Subject: Collin County Healthcare Facility, Parking Garage, and Medical Examiners
PCO No. 092; RFI #332 PG North and South Stair Entrances Level 2

Issue No. 092 - RFI #332 PG North and South Stair Entrances Level 2 Amount

RFI #332: PG - North and South Stairs Entrance at Level 2

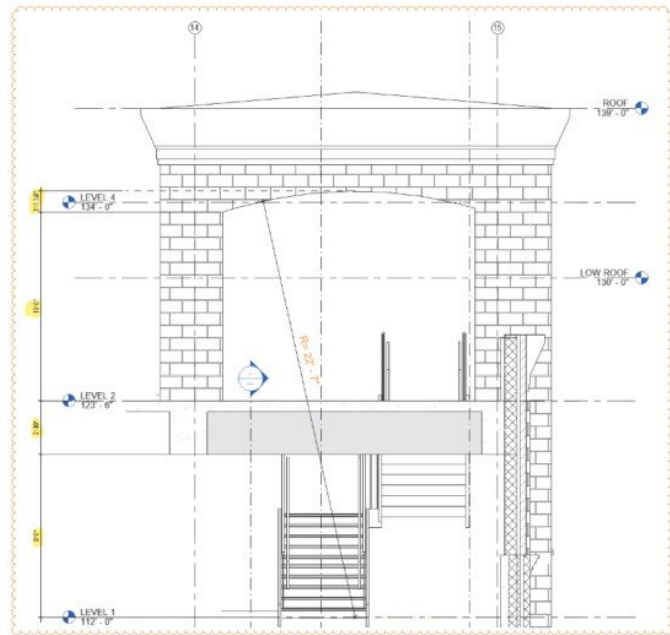
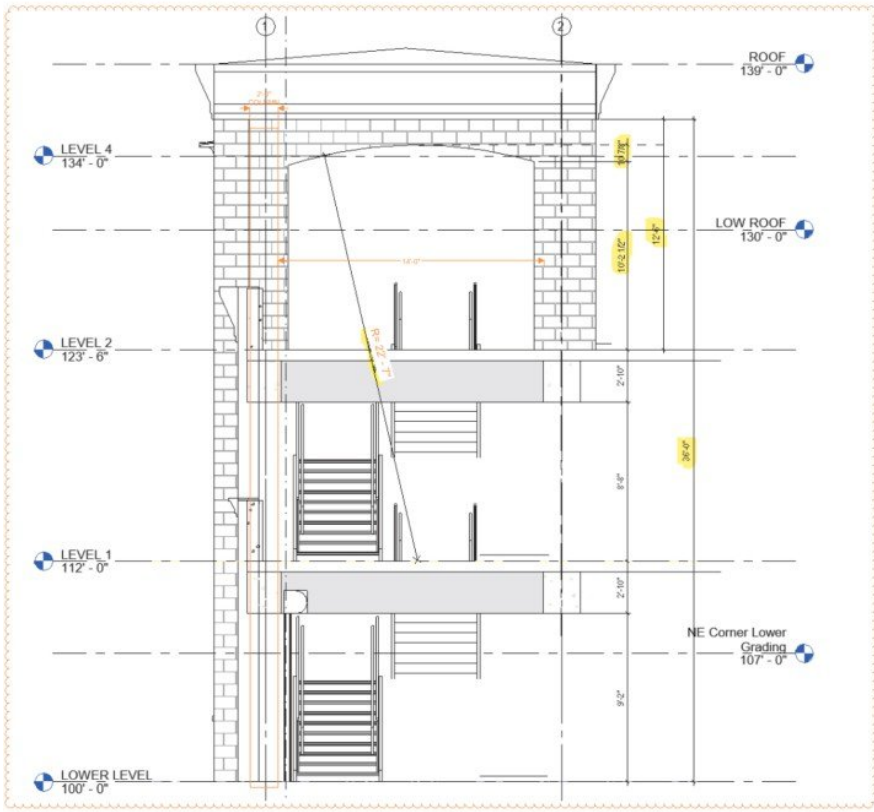
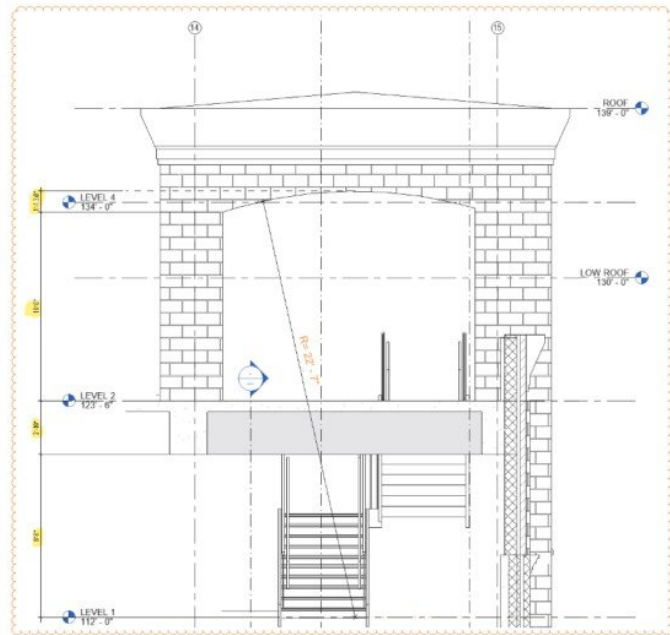
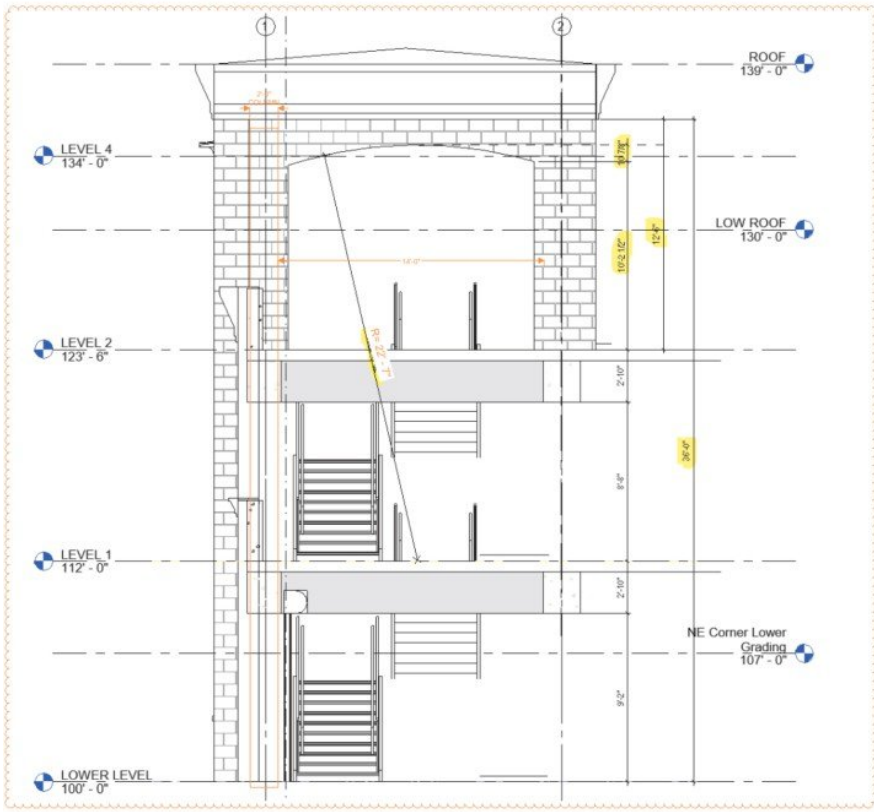
There are no sections or elevation details for the 13'-4" large openings at the north and south stair entrances on Level 2 of the parking garage. Could you clarify whether CFMF and masonry materials are required? If masonry veneer is needed, what type of material should be used for the backup support? Please provide details on this.

There are no sections or elevation details for the 13'-4" large openings at the north and south stair entrances on Level 2 of the parking garage. Could you clarify whether CFMF and masonry materials are required? If masonry veneer is needed, what type of material should be used for the backup support? Please provide details on this.

Please refer to dimensions requested on elevations from Submittal 04-40-00, additionally comments and coordination emails based on these 2 elevations with Jollay, this was discussed with them previously during the submittal process, as this shop drawing was returned many times for this exact locations.

Please refer to dimensions requested on elevations from Submittal 04-40-00, additionally comments and coordination emails based on these 2 elevations with Jollay, this was discussed with them previously during the submittal process, as this shop drawing was returned many times for this exact locations.

NORTH STAIR - LEVEL 2 | 1/4" = 1'-0" | 5

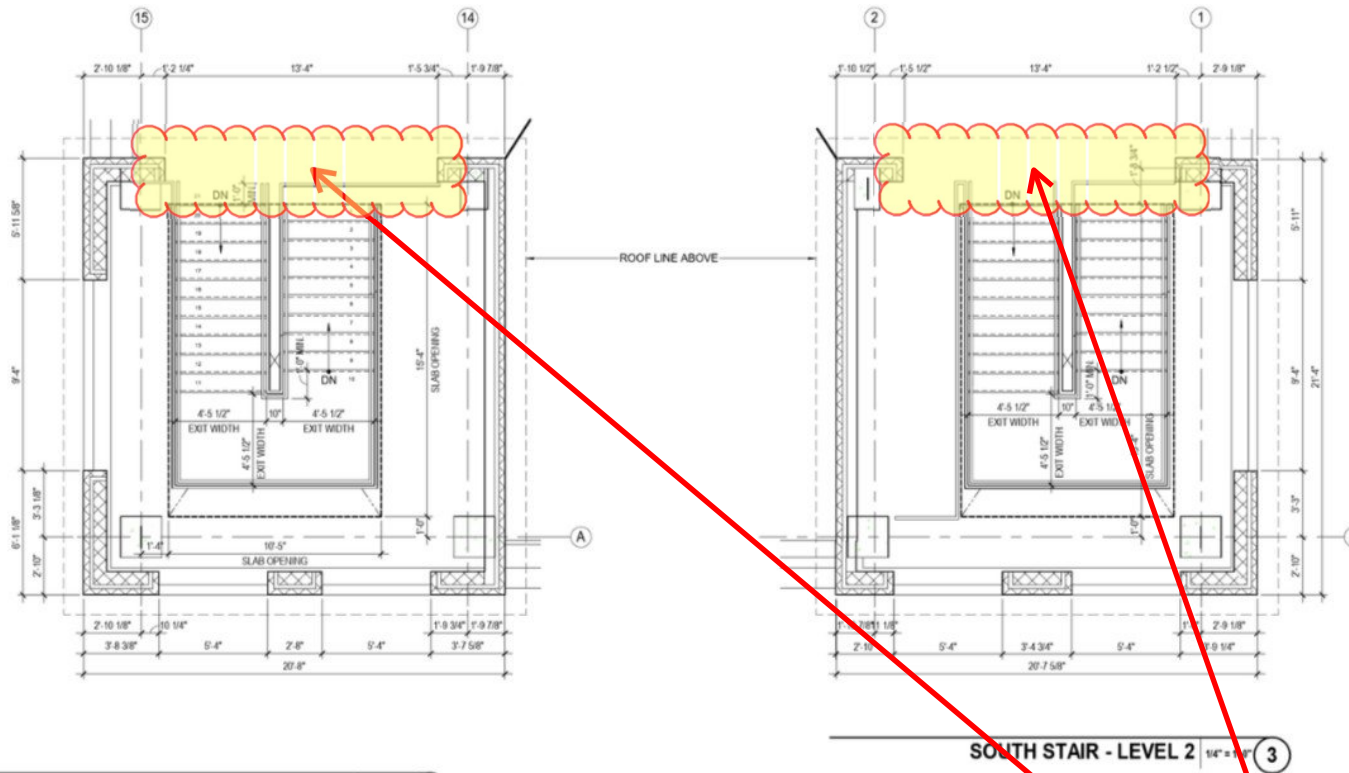
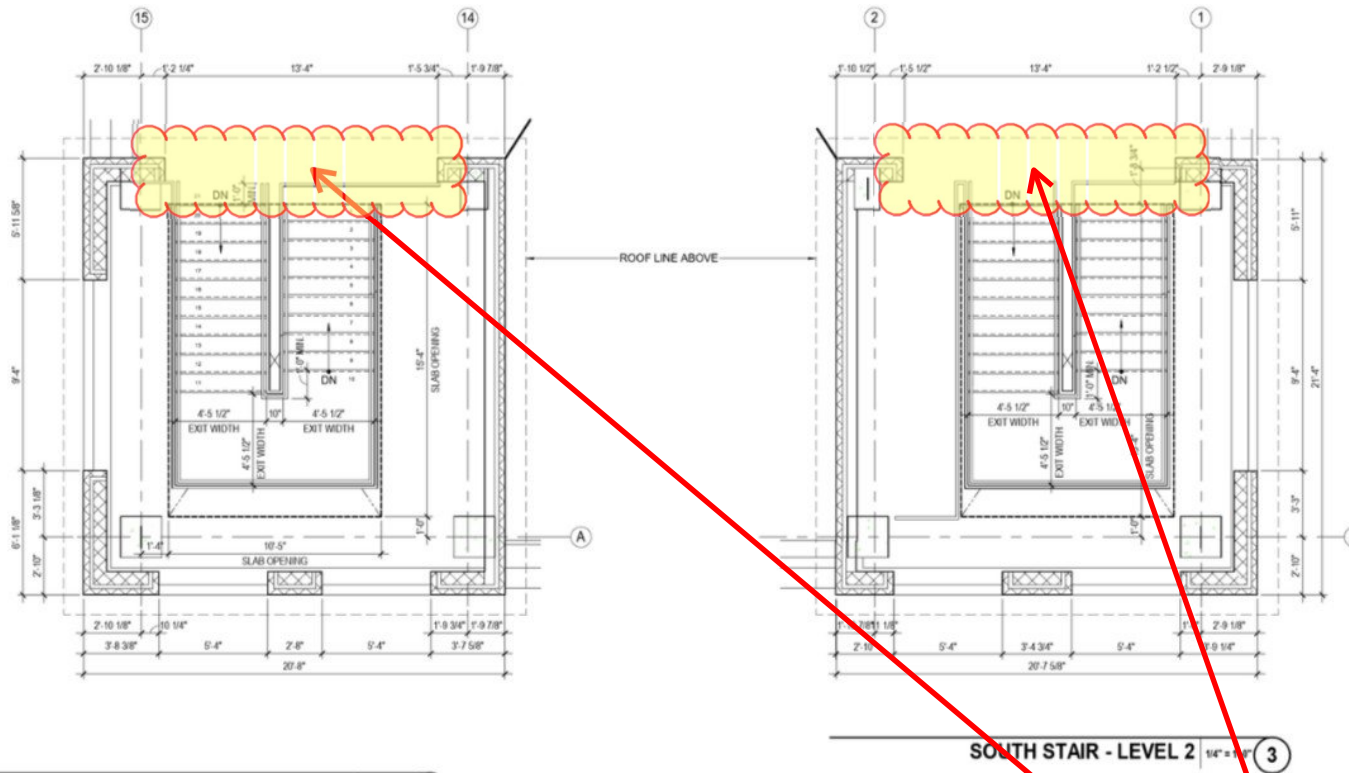
THERE ARE NO SECTION OR ELEVATION DETAILS FOR THESE 13'-4" LARGE OPENINGS AT THE NORTH AND SOUTH STAIR ENTRANCE ON LEVEL 2 OF THE PARKING GARAGE. ¿CAN YOU CLARIFY IF CFMF AND MASONRY MATERIALS ARE REQUIRED? IF MASONRY VENEER IS REQUIRED, WHAT MATERIAL IS NEEDED ON THE BACKUP SUPPORT? PLEASE PROVIDE DETAILS ON THIS.

THERE ARE NO SECTION OR ELEVATION DETAILS FOR THESE 13'-4" LARGE OPENINGS AT THE NORTH AND SOUTH STAIR ENTRANCE ON LEVEL 2 OF THE PARKING GARAGE. ¿CAN YOU CLARIFY IF CFMF AND MASONRY MATERIALS ARE REQUIRED? IF MASONRY VENEER IS REQUIRED, WHAT MATERIAL IS NEEDED ON THE BACKUP SUPPORT? PLEASE PROVIDE DETAILS ON THIS.

SEE WPM RESPONSE ATTACHED AT THE END.

WPM RESPONSE

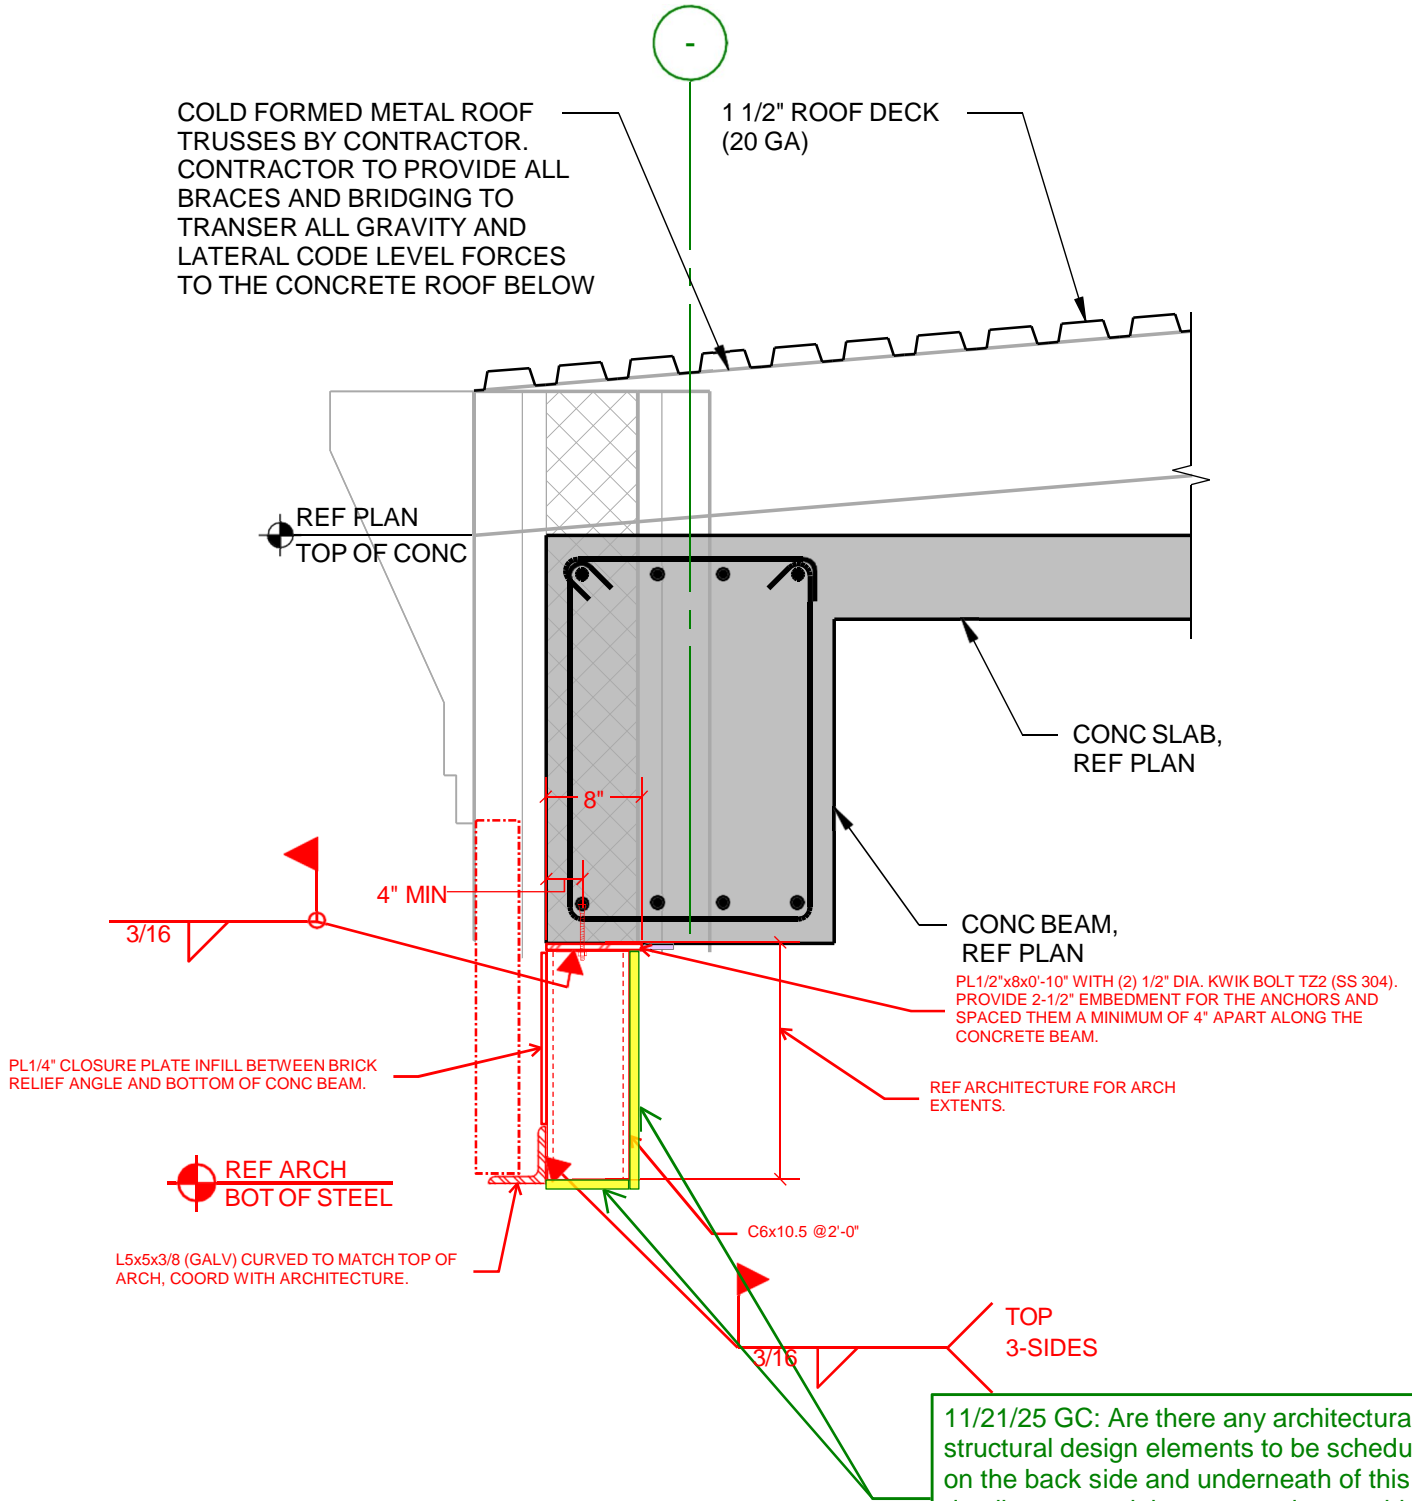
11/21/25 GC: Are there any architectural or structural design elements to be scheduled on the back side and underneath of this detail to conceal the structural assembly? Currently, looks to be exposed, per this detail.

- NOTES**
1. GC TO SCAN EXISTING CONCRETE PRIOR TO DRILLING.
 2. ALL STEEL TO BE GALVANIZED.
